Our Ref: 371293-L03 (00)

Re: Revised Ground Movement Analysis in Response to CGL's Comments of 22nd July 2014

Further to CGL's comments of the 22nd July 2014, the revised cross-section of the site containing updated level information from SHH Architects (633(PL)005 Rev C see Appendix A) and updated drawings received from HRW (901/SK/020 P11 and 901/SK/023 P1 see Appendix B) we would make the following comments.

Figure 1 Modified Cross-Section of the Site Produced by SHH Architects

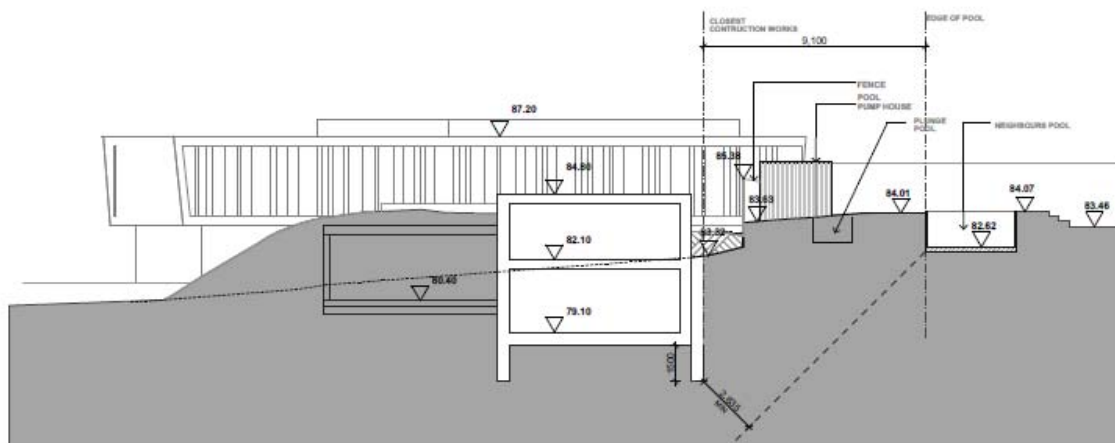
These analyses have considered the dimensions presented in Figure 1 recently provided by SHH Architects. These have also been summarised in Table 2.

Figure 2 Strain Rosette Showing Damage Categories for No.49 Fitzroy Park Assuming High Stiffness Retaining Wall

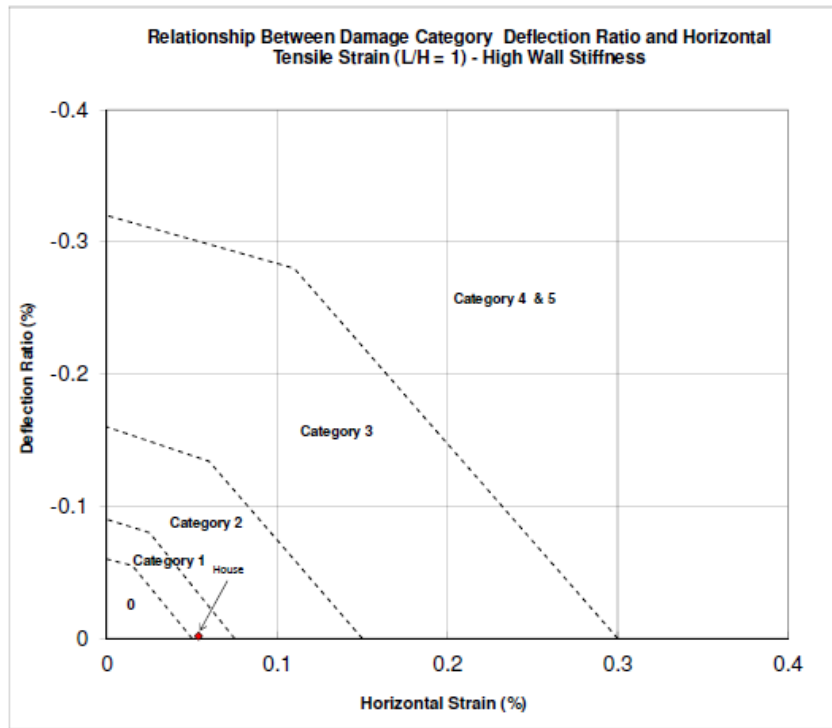
The associated deflection ratio and horizontal strain for No.49 Fitzroy Park has been plotted on a strain rosette in the way recommended in CIRIA 580 in Figure 2. This show the estimated damage to fall into Category 1 as defined in CIRIA 580 (see Appendix E) assuming a stiff retaining wall system is adopted. It should be stressed however that the damage categories that have been superimposed relate to masonry structures with mortar and as such are only relevant to the house at 49 Fitzroy Park. Such structures are far more susceptible to damage than the other structures considered which appear to be constructed of reinforced concrete and timber.

Based on the High Stiffness wall assessment the damage to the house at No.49 Fitzroy Park falls into Damage Category 1 (very slight) as defined in CIRIA 580. Should the wall stiffness drop to moderate this will move to Damage Category 2 (slight). Both these damage categories are considered acceptable by Camden Planning Guidance document CPG4.

Figure 3 Strain Rosette Showing Damage Categories for No.49 Fitzroy Park Assuming Moderate Stiffness Retaining Wall

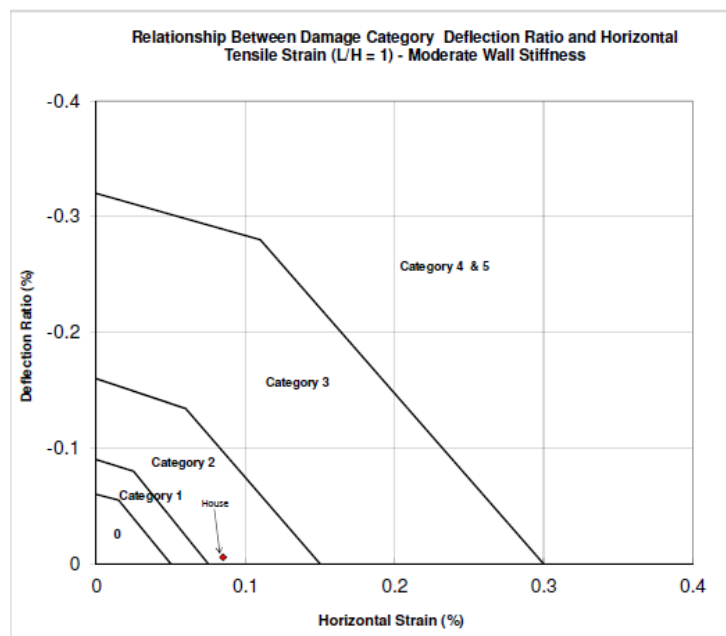
The associated deflection ratios and horizontal strains for the house at 49 Fitzroy Park have been plotted on a strain rosette in the way recommended in CIRIA 580 in Figure 3. This shows the estimated damage to fall into Category 2 as defined in CIRIA 580 (see Appendix E) assuming a moderately stiff retaining wall system is adopted. It should be stressed however that the damage categories that have been superimposed relate to masonry structures with mortar and as such are only relevant to the house at 49 Fitzroy Park. Such structures are far more susceptible to damage than the other structures considered which appear to be constructed of reinforced concrete and timber.

Drawing No: **901/SK/023** Revision: **P1**

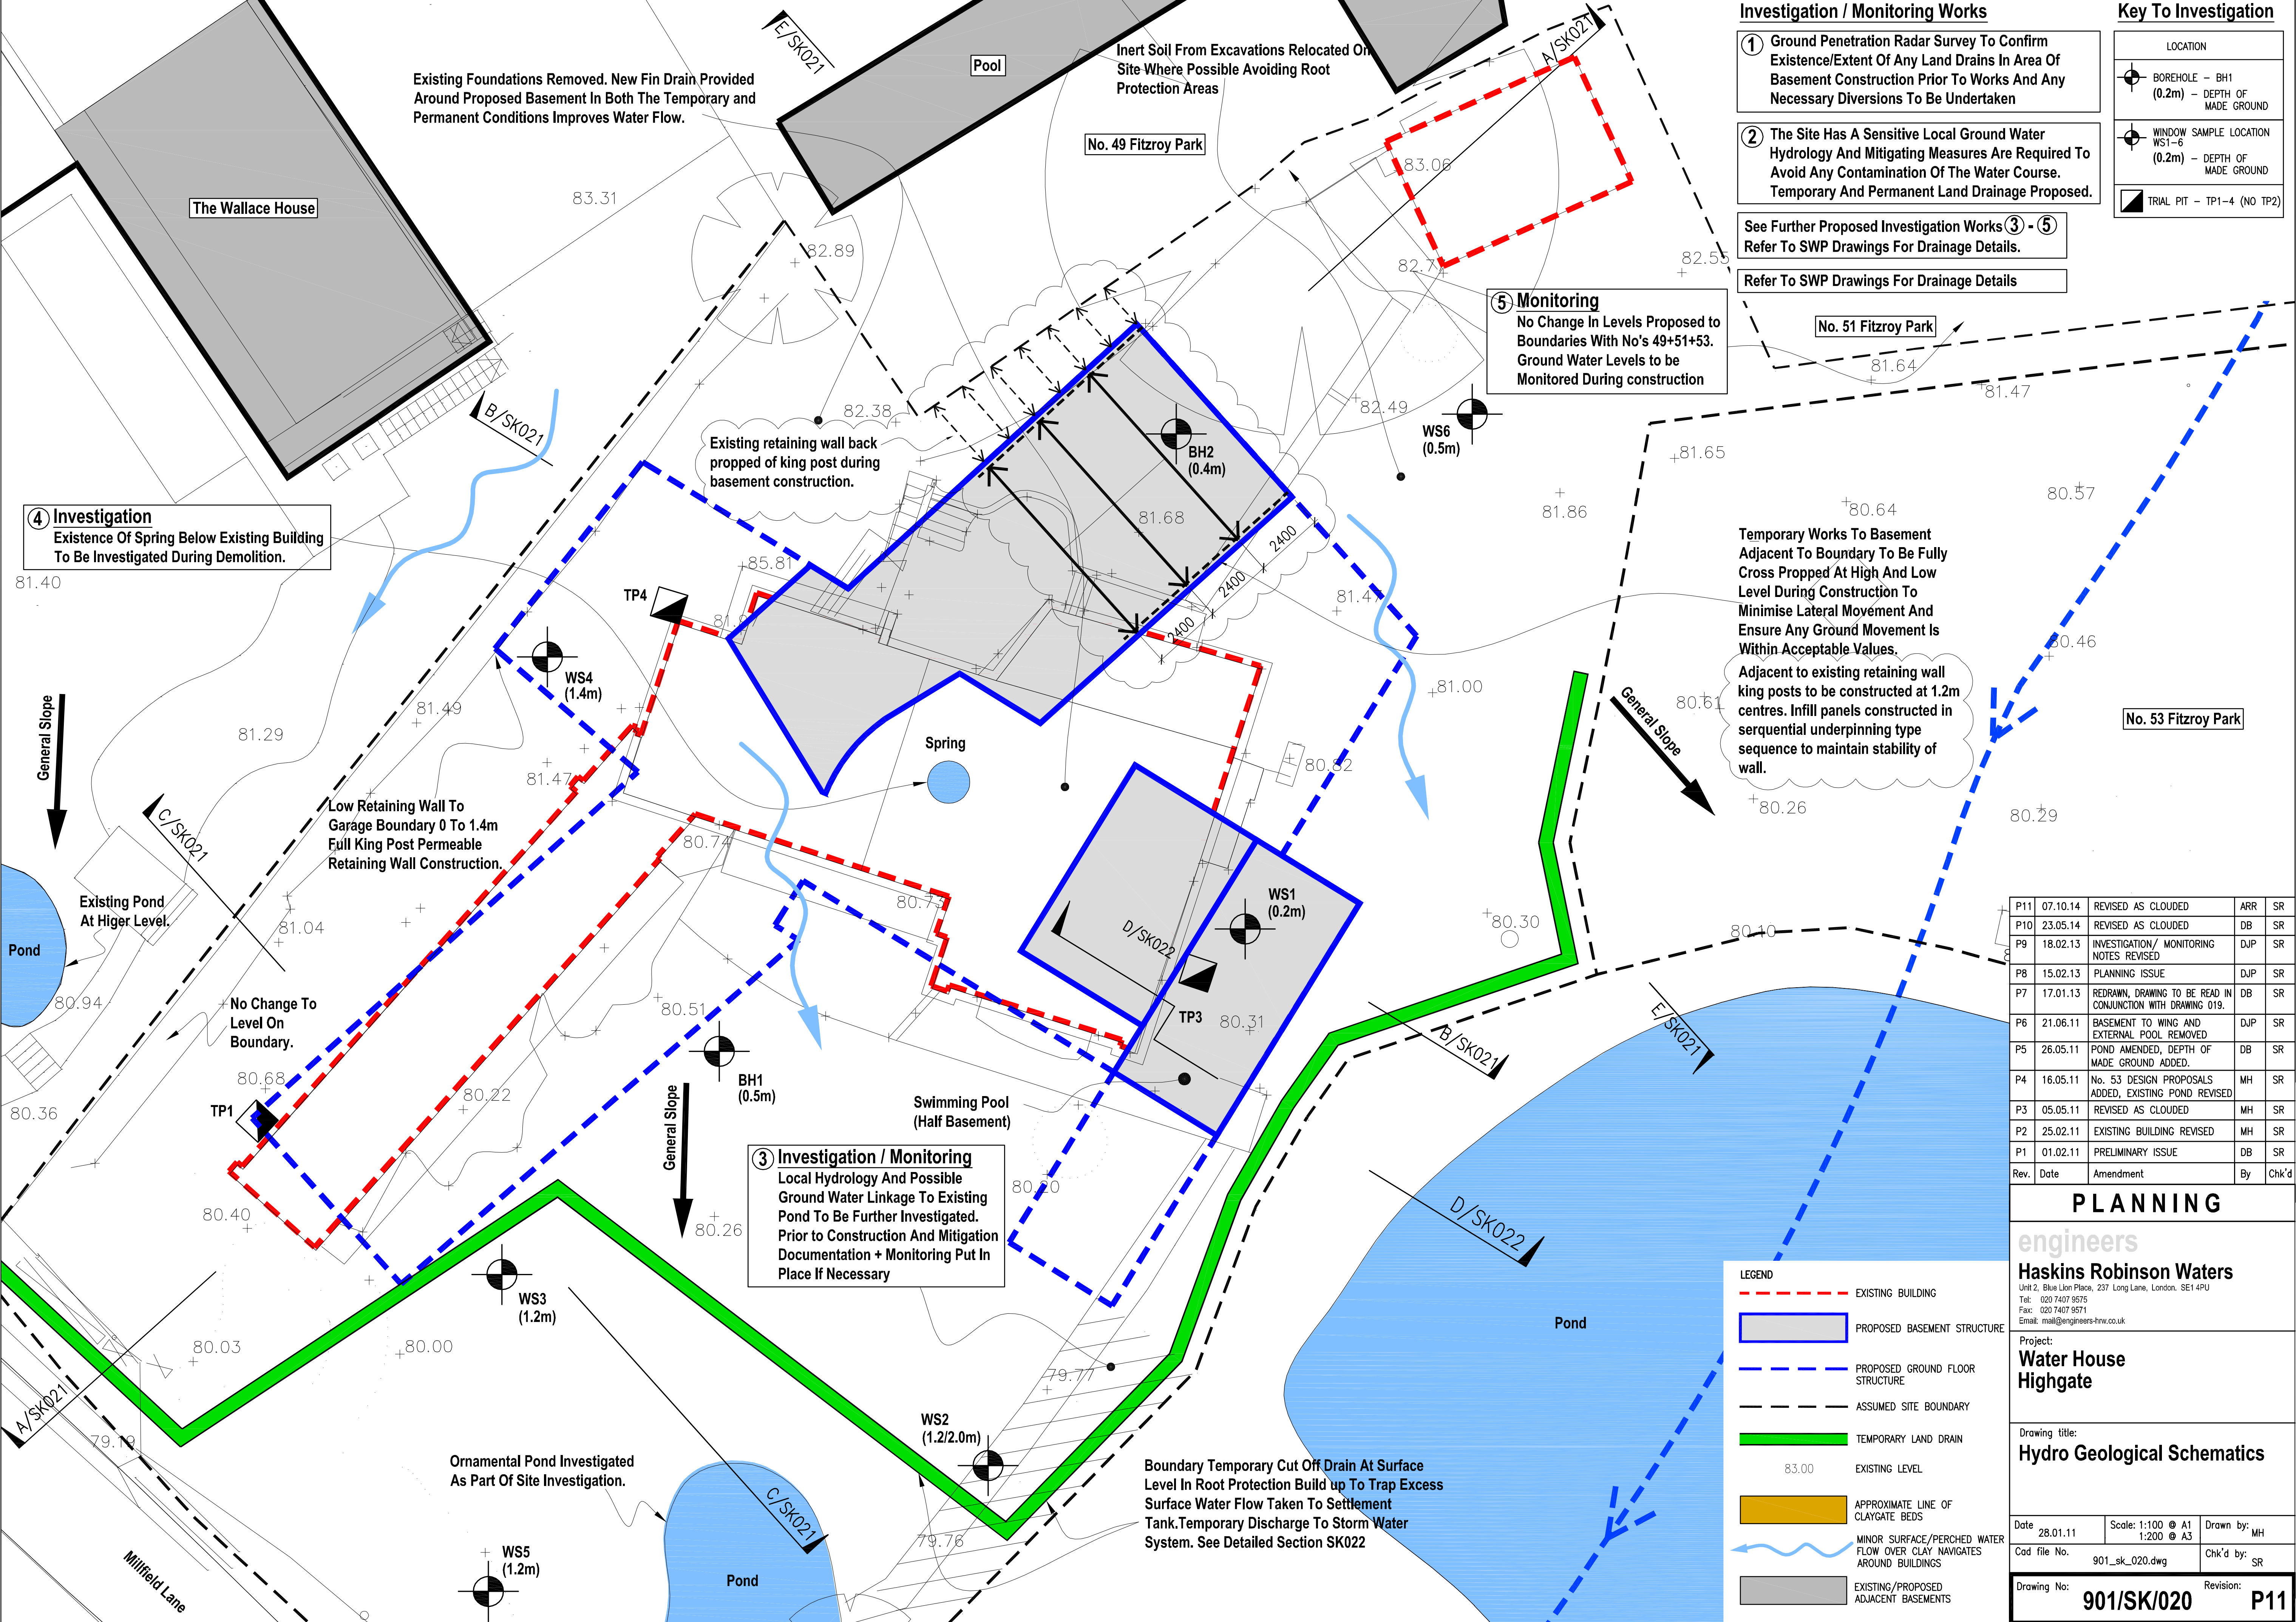
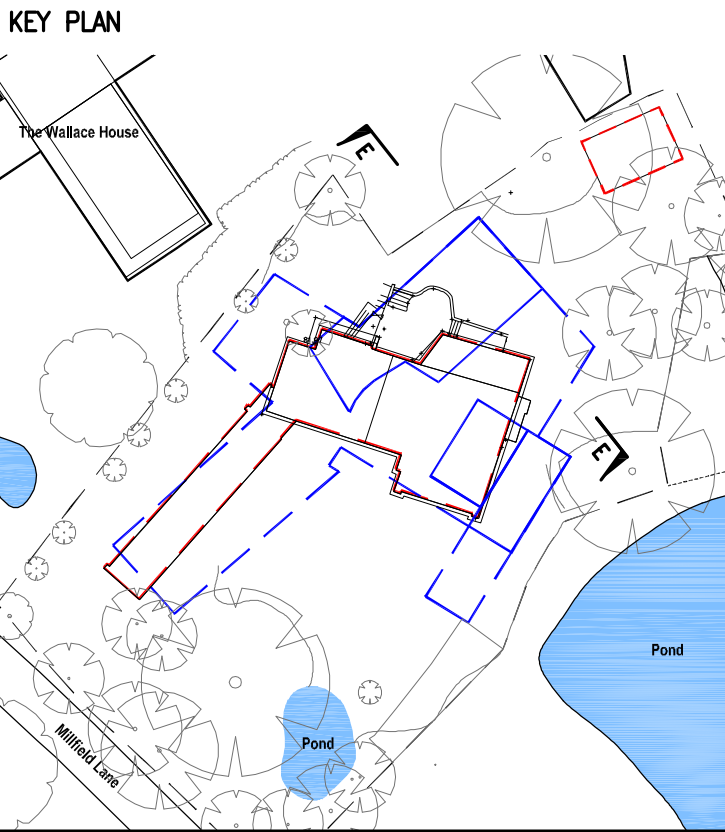
It is understood from drawings 901/SK/020 P11 and 901/SK/023 P1 that it is intend to reduce the spacing of the king posts from 2.4m to 1.2m to stiffen the behaviour of the wall and facilitate construction adjacent to the boundary retaining wall. In addition to this it is understood that a wailing will be installed near the top of the wall and that stiff props will be adopted to support the wailing at this level at alternate king post locations. Further to this it is also understood that the existing concrete retaining wall located on the boundary between No.49 and the Waterhouse will be propped off the wailing at each king post location to prevent lateral movement.

Based on this modification it is our opinion that the proposed retaining wall can be considered as a High Stiffness wall for the purpose of carrying out a C580 movement assessment assuming that a high standard of workmanship is adopted during construction and that the temporary props are replaced as soon as possible by permanent props forming part of the permanent works. A suitably experienced and competent contractor should be able to ensure that the required standard of workmanship is achieved.

In conclusion the proposed changes to the king post wall are considered to ensure it falls into the category of High Stiffness wall as defined in CIRIA 580 assuming that a high quality of workmanship is adopted. A suitably experienced and competent contractor should be able to ensure that this standard of workmanship is achieved.
